TO THE LAND COURT OF QUEENSLAND

**Further Supplementary Individual Expert Report –
Groundwater conceptualisation and quality**

Dr Matthew Currell

REGISTRY: Brisbane
NUMBER: EPA495-15
MRA496-15
MRA497-15

Figure 1 – Comparison of fault locations in the AEIS groundwater model following the IESC’s 2014 advice (a) and immediately prior to IESC’s 2016 advice (b).

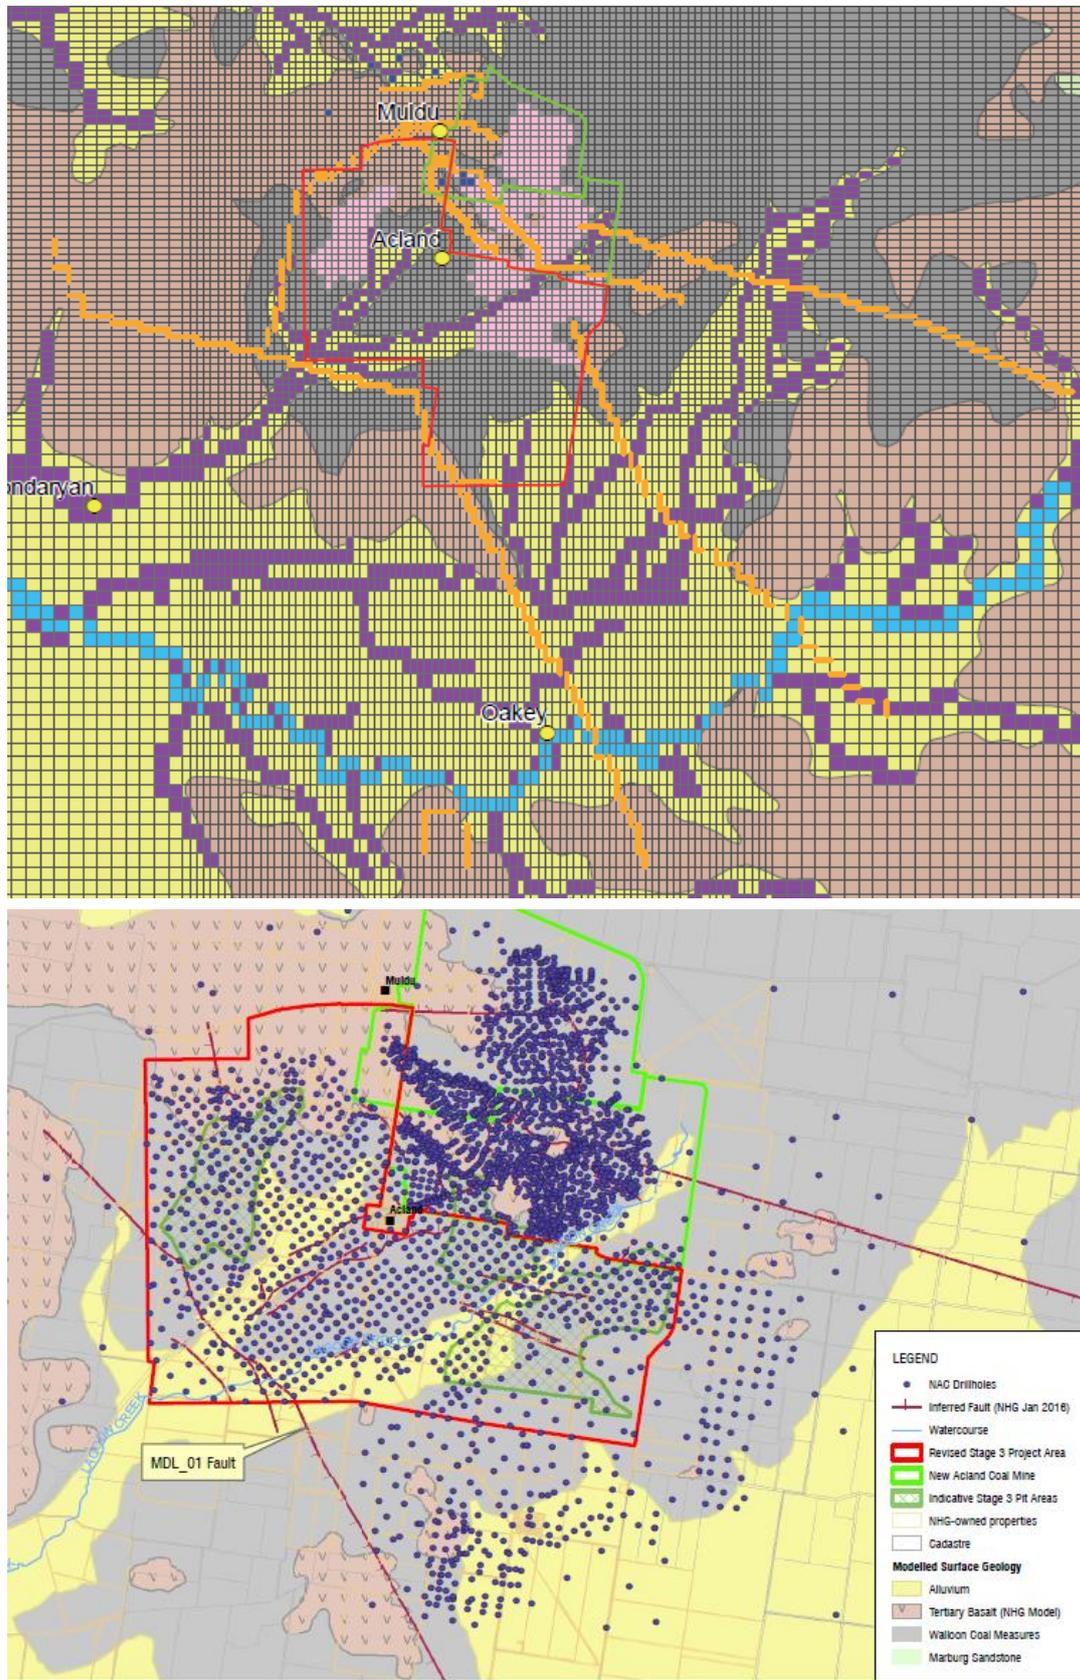
- (a) The observation that many of the faults in the AEIS numerical model don't match the drilling and mapping data. This is yet to be resolved and incorporated into a new conceptual or numerical model of the site (see figure 1, below);

- [40] Regarding the first issue (paragraph (a) above), it is clear that the inferred faults shown on the map in SLR 2016a and SLR 2017 are quite different from the pattern of faults in the AEIS model that was reviewed by the IESC in 2014 and updated in response to their advice. The maps below show a comparison of locations where faults were included in the model at this time (in orange), compared to those mapped in the recent SLR reports (SLR 2016a & SLR 2017):

[41] As can be seen from this comparison, a number of faults in the AEIS model occur in places where they are not mapped in the field, or with significantly different orientations and extent

- [43] Importantly, the 'sensitivity analysis' of the effect of faulting presented in SLR 2016a still uses the previous conceptualisation of faults presented in 2014 and 15 (top image of figure 1) rather than a conceptualisation which has the faults located in the model where they were mapped in the field (the bottom image of figure 1, and figure 2, above). Consequently, the IESC's comment in 2016 that a '*Sensitivity analysis on the role of faulting has been undertaken within the groundwater model by removing the horizontal flow barriers that represented faults*' in my opinion gives a false impression that a rigorous sensitivity analysis of the effect of faulting has been conducted. The significant difference between the faulting pattern in the AEIS model and the actual field data will require (as foreshadowed in the SLR

- [67] As is clear in the AEIS (see Figure 1 above), the most recent version of the groundwater model in fact contains representations of many more than five faults within the project area. In this version of the model, all of these faults are represented as complete barriers to groundwater flow, or in a manner which doesn't allow the modeller to control their hydraulic behaviour (e.g. faults included as 'walls' with gaps selectively added between adjacent cells).

2016b report) a re-build of the hydrogeological conceptualisation with faults included in correct locations, with more appropriate hydraulic properties (and a range of possible properties tested in the modelling), before a thorough sensitivity analysis of the effects of faulting can be completed. The results of this sensitivity analysis will also be impacted by changes in the layering and hydraulic parameters of the aquifers in the model, and revised water balance. As with other aspects of the hydrogeological conceptualisation and model, it can be expected that this new conceptualisation would lead to significantly different predictions of groundwater impacts from the project compared to the AEIS, with significant implications for groundwater users.

Figure 2 - Pattern of faulting provided by NAC to B. Barnett during development of EIS groundwater model (from Brian Barnett's statement of evidence, 10/05/2016¹⁶).

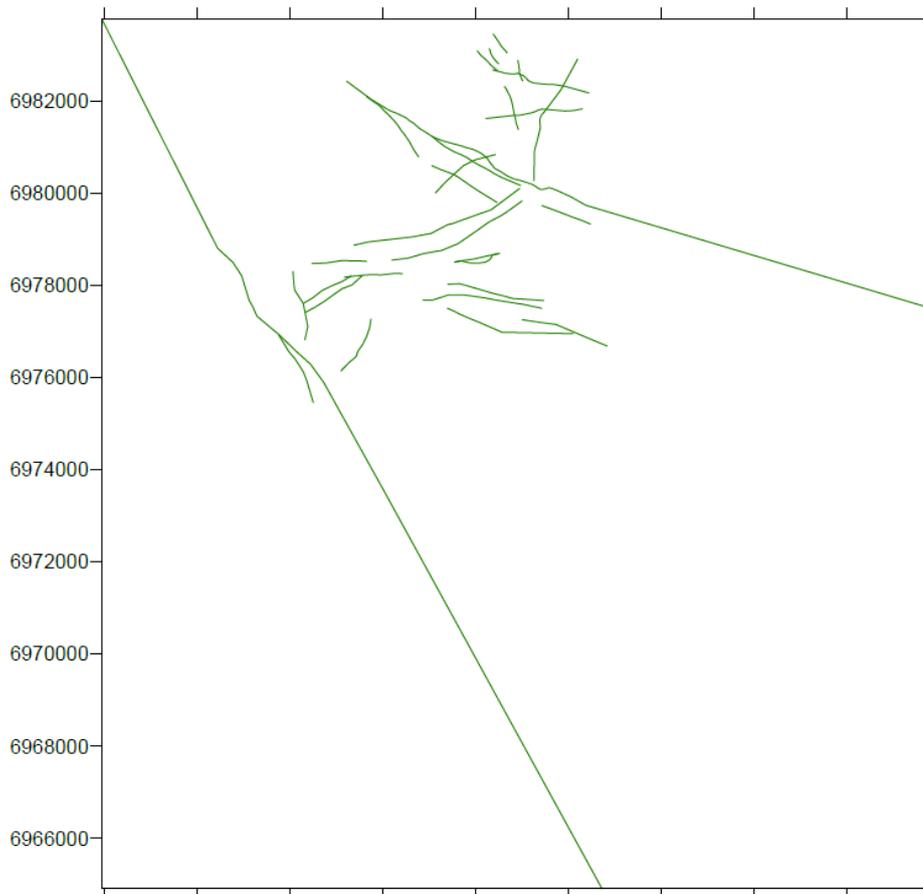
(as discussed in my supplementary expert report of 6/5/2016¹⁵). Additional faults occur in the field mapping but are not included within the model. The map of faults included within the SLR 2016a and 2017 reports is in fact very similar to the map of faults that was provided to SKM during development of the original groundwater model prior to 2013:

- [42] Much of the mapping of the faulting pattern presented in SLR 2016a thus appears to have already existed and to have been provided to the consultants during development of the original groundwater model for the EIS and AEIS. It is thus not clear how much additional drilling (other than the new monitoring bores described in SLR 2016a and SLR 2016b) has taken place since the AEIS model to characterise the faulting pattern beyond that already provided (on the basis of coal exploration bore logs) during the initial groundwater model development.

Figure 3 – Monitoring bores proposed in original GMIMP (2014) and the revised (2016) GMIMP

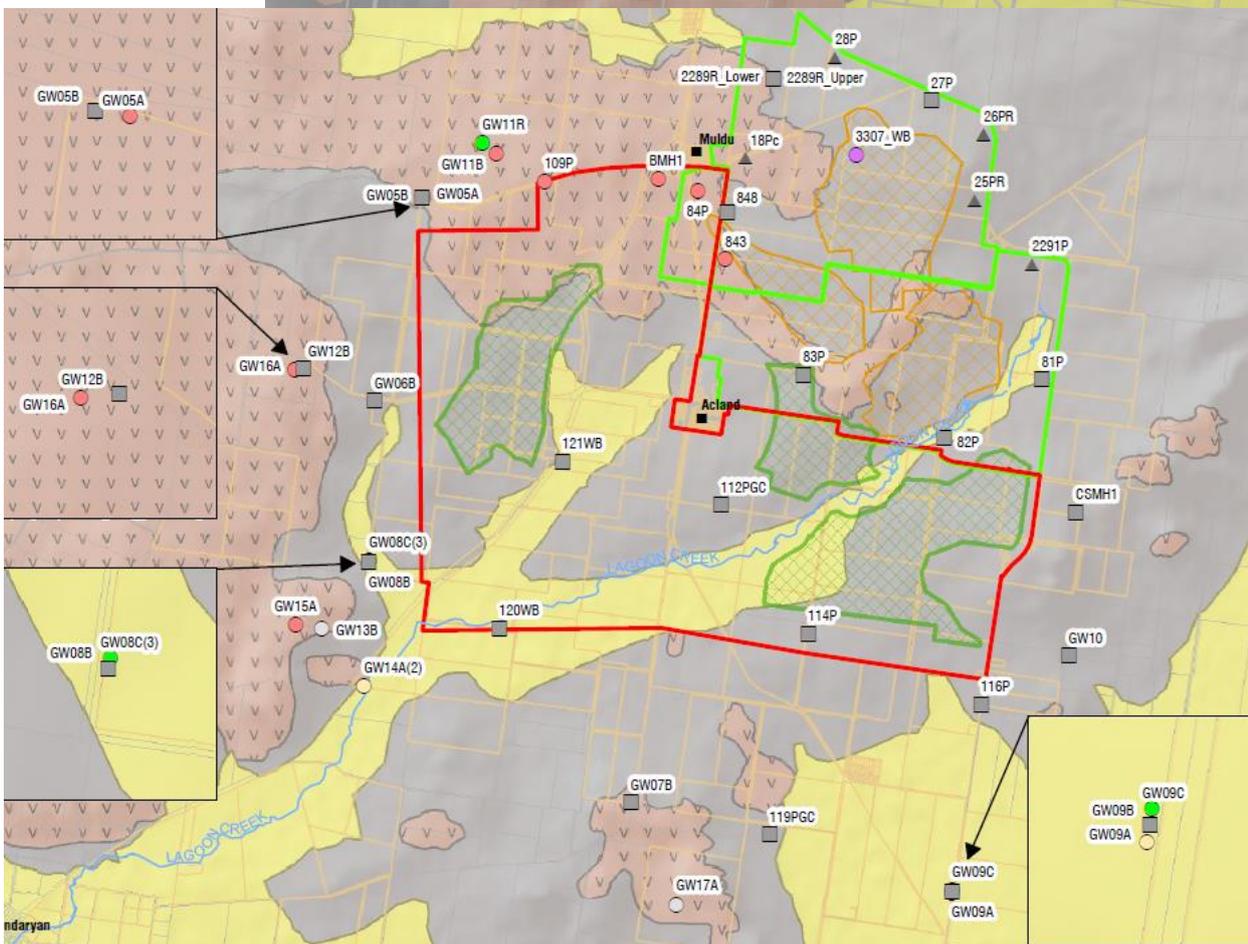
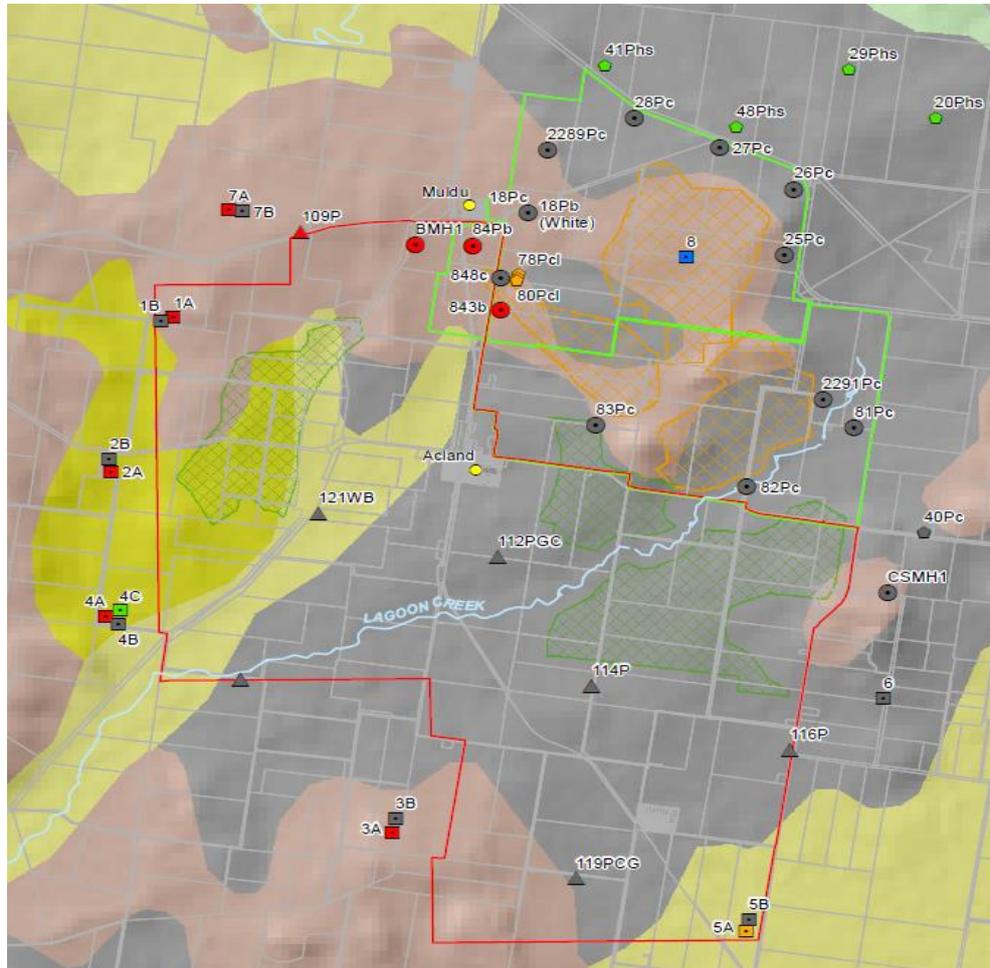
- [54] The drilling program described in the report answers some outstanding questions regarding the hydrogeology of the area – namely, the area of alluvium adjacent to Lagoon Creek to the southwest of the mine was drilled, and as proposed by NAC and its groundwater experts during the first JER, the area was found to be un-saturated, and therefore no monitoring bore could be constructed.

[55] The new conditions in the federal approval for the project mention the need for ‘early warning’ bores to detect drawdown before this propagates into areas where groundwater users have bores. This is a welcome condition, however, in order to have early warning bores there needs to be monitoring conducted along transects with multiple bores at greater and lesser distances from the proposed mine pits. In the case of the revised GMIMP (see figure 3, above), it can be seen that there is only a single ‘ring’ of bores constructed in most of the major aquifers (apart from the WCM, where there are multiple bores at different distances). In order for the ‘early warning’ system to be effective, there need to be at least two bores along a compass line, closer and further away from the mine (e.g. near the landholder bores) to assess early drawdown propagation before impacts reach receptors.
